**Nuclear Innovation  
North America LLC**

July 7, 2014  
U7-C-NINA-NRC-140013  
10 CFR 2.390

South Texas Project  
Units 3 and 4  
Docket Nos. 52-012 and 52-013  
Response to Request for Additional Information

Attached are the Nuclear Innovation North America, LLC (NINA) responses to NRC staff questions in Request for Additional Information (RAI) letters 439, 440, 441, and 446 related to SRP Section 09.01.02. The attachments to this letter contain the responses to the following RAI questions:

FIGURE 2.9: ELEVATION VIEW DETAIL F

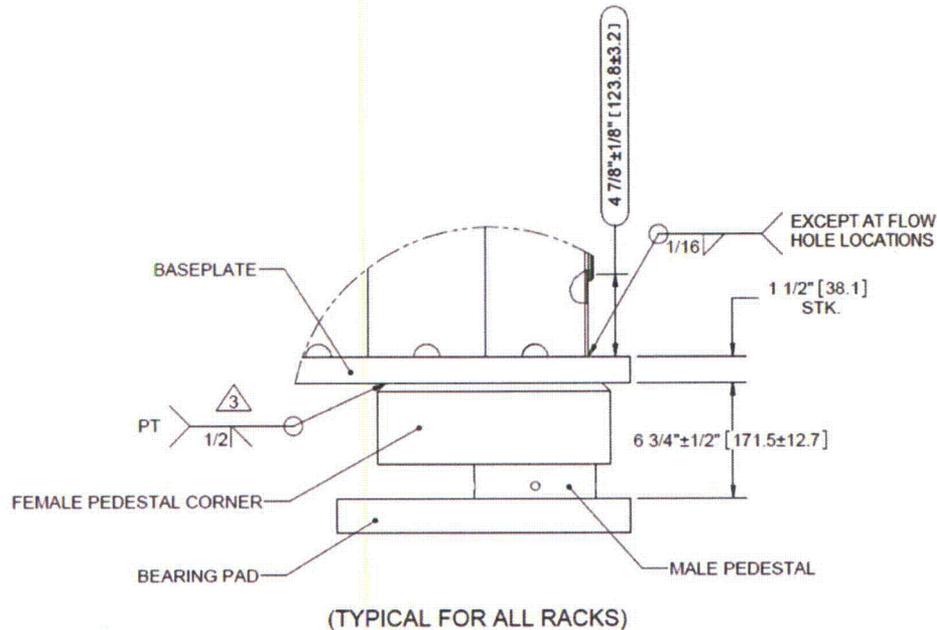
- (b) The fourth paragraph states, "The baseplate is attached to the box assemblage by fillet welding the perimeter of the box assemblage to the baseplate as shown in Figure 2.9." Figure 2.9 includes the note. "WHERE POSSIBLE ON ALL RACKS". Based on past fabrication of similar racks, show a plan view of the actual fillet weld path around the perimeter of the box assemblage. What weld geometry assumption is used in the calculation of stress in the fillet weld?

- (b) Holtec Report HI-2135462, Figure 2.9, will be revised to change the weld note from "WHERE POSSIBLE ON ALL RACKS" to "EXCEPT AT FLOW HOLE LOCATIONS." A copy of the revised Figure 2.9 is shown below.

FIGURE 2.11: TIE BAR WELD DETAILS

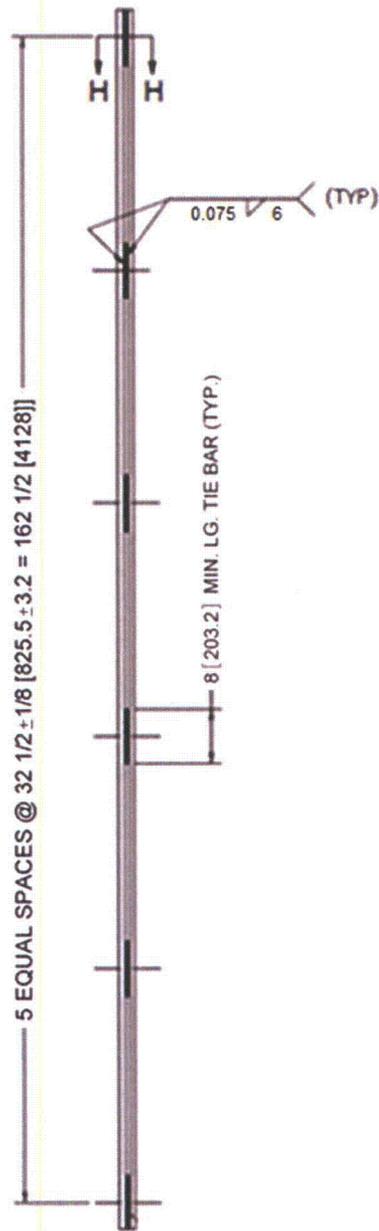
NINA Letter, U7-C-NINA-NRC-130059, dated November 14, 2013, Attachment 5, Item 3 provides stuck fuel assembly evaluation required by the ABWR DCD, Subsection 9.1.2.3, but is not currently included in Holtec Report No. HI-2135462. In light of the information in Item 1, Figure 2.11, which shows that the cell-to-cell welds are 8 inches long, explain the assumption "that the net resultant pull force is resisted by only two 6-inch long cell-to-cell welds [...]," which is found in Item 3c) of Attachment 5.

The minimum cell-to-cell weld length is 6 inches as shown on Sheet 4 of Holtec Drawing 8946. In order to form this weld, an 8-inch long tie bar is positioned between the opposing corners of the cells being welded at each cell-to-cell weld location. The tie bar length is 2" longer than the minimum required weld length to avoid potential weld issues at the ends of the tie bar. Figure 2.11 shows the length of the tie bar, but it does not indicate the minimum cell-to-cell weld length.

Holtec Report HI-2135462, Figure 2.11, Tie Bar Weld Details, will be revised as shown on the following page to include the details described above.

**Figure 6.7.4 – Rack-to-Rack Impact LS-DYNA Model**

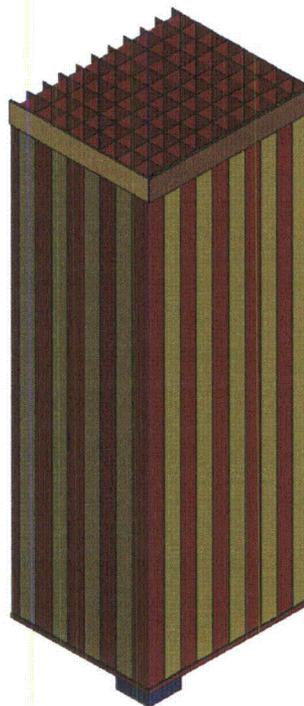
- (2) Regarding the buckling analysis of the cell wall subject to rack-to-rack impact, the proposed changes to Holtec Report No. HI-2135462 state that the impact load is applied to the back surface of the rigid impactor as a uniform pressure across the full width of the rack. The staff requests that the applicant provide the technical basis for the assumption of the uniform pressure across the full width of the rack. Additionally, explain why the impact force time history was amplified to have a peak force of 557 kips, and how the displacement time history of the impactor was computed.

- (2) The impact load is applied across the full width of the rigid impactor since the DYNARACK solution indicates that both end of the bumper bar (along the side of the rack) are in contact when the maximum rack-to-rack impact load occurs. The impact force time history, which is obtained from the dynamic simulation of the spent fuel racks using DYNARACK, is amplified by a factor of 3 to demonstrate that the critical buckling load is at least 1.5 times greater than the maximum predicted impact load. The displacement time history of the impactor is computed by LS-DYNA based on the geometry and strength properties of the rack and the impact force time history.

The ability of the rack to withstand the maximum rack-to-rack impact load is analyzed using the Holtec QA validated commercial finite element code LS-DYNA. The objective of the analysis is to demonstrate that the rack cell structure will not buckle under 1.5 times the maximum impact load, as required by Section III, Appendix F, F-1331.5 of the American Society of Mechanical Engineers (ASME) code. Figure 6.7.4 shows the LS-DYNA model used to evaluate the impact capacity of the rack. The LS-DYNA model takes advantage of the symmetry of the impact problem by applying appropriate boundary conditions and adjusting the cell wall thickness at the symmetry plane. As shown in the model, the top of the impacted rack is in contact with an 8" wide rigid rectangular plate, which represents the impactor (i.e., the adjacent rack) in a rack-to-rack impact event. The bounding impact force time history, which is obtained from the WPMR analysis and further amplified by almost a factor of 3 (such that it has a peak value of 557 kips), is applied to the back surface of the rigid impactor as a uniform pressure. Figure 6.7.5 shows the impact force time history applied to the rack top. The displacement time history of the impactor for the analyzed rack-to-rack top impact is presented in Figure 6.7.6, which shows no sudden increase until 0.017 seconds when the impact force reaches 339.4 kips. At the time that the maximum impact load (210.5 kips)

Figure 1.1.2 – Pedestal and Bearing Pad Locations for STP 3 & 4 ABWR Fuel Storage Racks  
 (All dimensions are nominal)

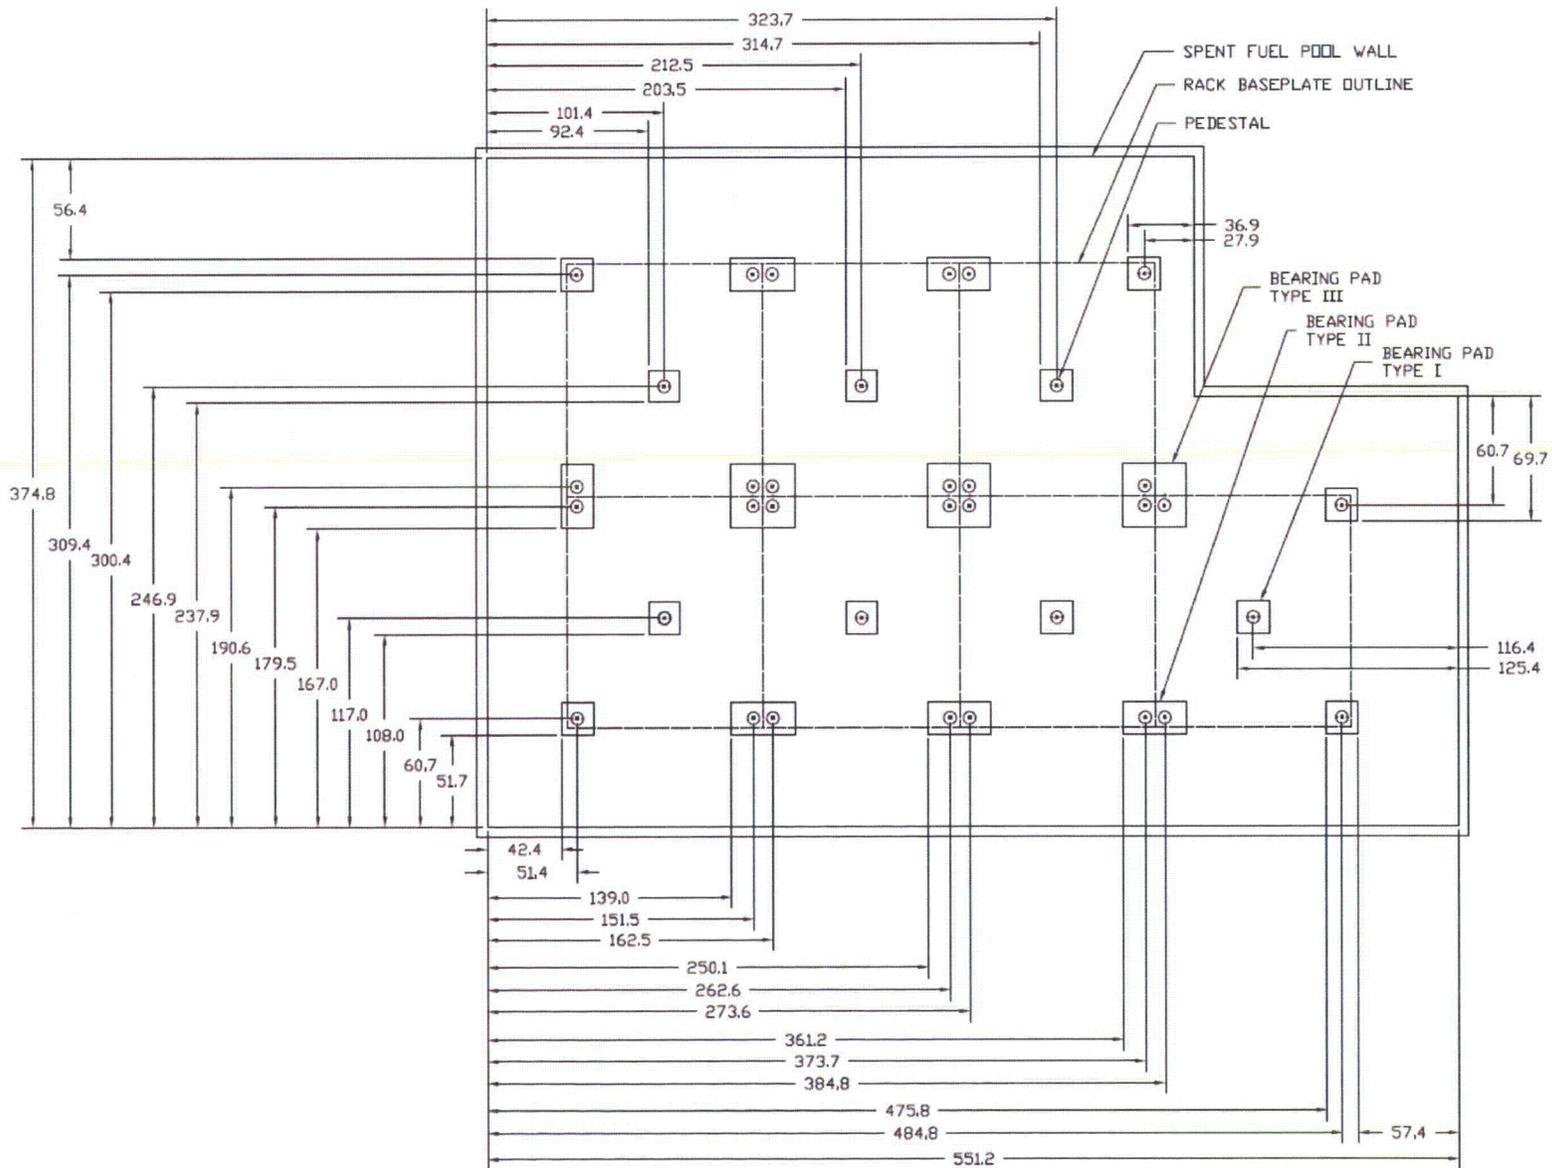
- (1) Figure 2.7, Detail F, appears to show that that the typical corner pedestals are not located centrally on the bearing pad, and may not have the minimum edge distance of 5.5". The applicant is requested to explain how minimum required edge distance is achieved for the corner pedestals including description of the bearing pads being used for adjacent rack pedestals.
- (2) The response provided a mark-up of Section 6.9. It appears that the applicant updated the second paragraph of the section with the revised bearing pad size. However, the response does not include all changes needed for Section 6.9 to reflect the change to the bearing pad size. Therefore, the staff requests that the applicant revise Holtec Report No. HI-2135462, Section 6.9, to be consistent with the use of 18"x18" bearing pad size.

- (1) Holtec Report HI-2135462 will be revised to include new Figure 1.1.2, Pedestal and Bearing Pad Locations for STP 3 & 4 ABWR Fuel Storage Racks. Figure 1.1.2 shows the size and position of all SFR bearing pads and the position of each pedestal on the bearing pad.

Figure 1.1.2 shows the size and placement of each bearing pad and the positioning of the spent fuel rack pedestals on the bearing pads.

Figure 6.7.1 – Finite Element Model of 3 x 3 Cell Array

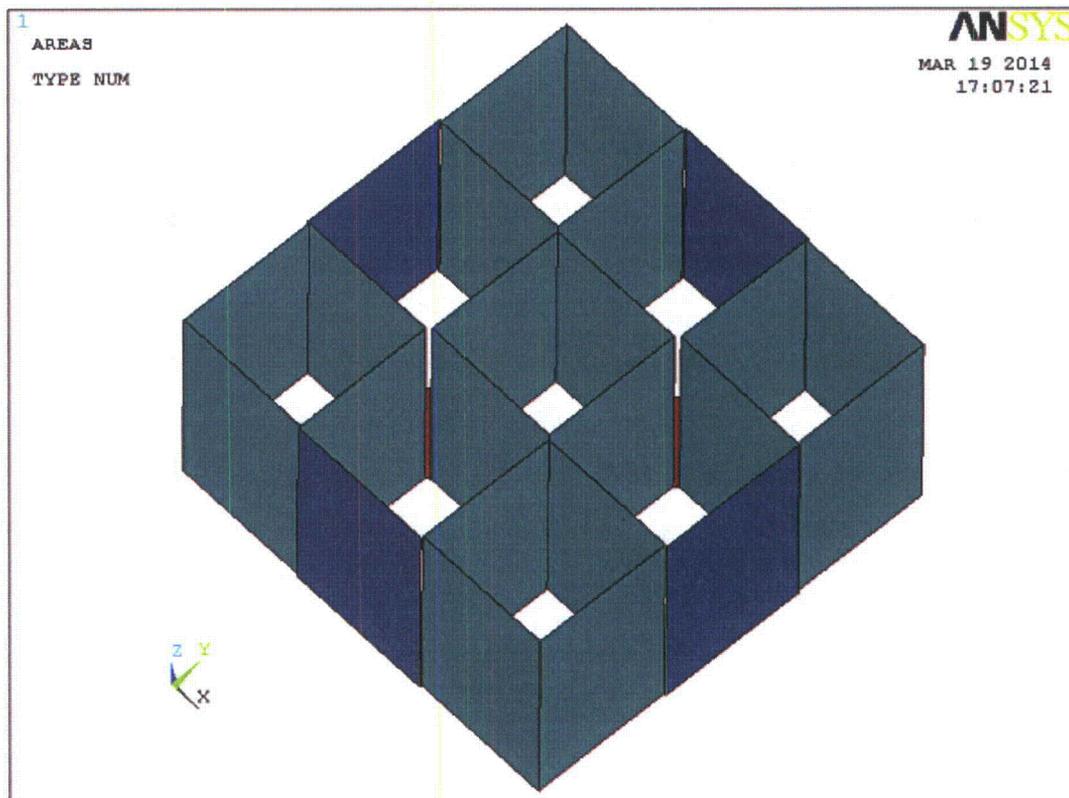
- (d) Section 6.7.10, "Potential for Cell Wall Buckling," presents a summary of a hand calculation using a classical buckling formula, with  $K = 3.44$ . There is no technical basis provided for using this value of  $K$ . Add a figure to the report depicting the simplified buckling model, showing the coordinate system, dimensions, boundary conditions, and loading. Provide the technical basis for the conservatism of the simplified model, the assumed boundary conditions, and the selected value of  $K$ .

The finite element model, which is shown in Figure 6.7.1, represents a 3 x 3 array of storage cells at a rack corner location. The modeled height of the cells is 10", which exceeds the distance from the top of the rack base plate to the bottom of the neutron absorber sheathing. No credit, however, is taken for the stiffening effect of the neutron absorber sheathing, which is welded directly to the cell wall. This is the most critical area for buckling since the compressive stresses are maximum at the base of the cells. The bottom edges of the finite element model are simply supported, and the top edges are laterally restrained in the x and y directions. The cell walls are assigned bi-linear elastic plastic material properties consistent with the strength properties of SA-240 304 at 200°F.
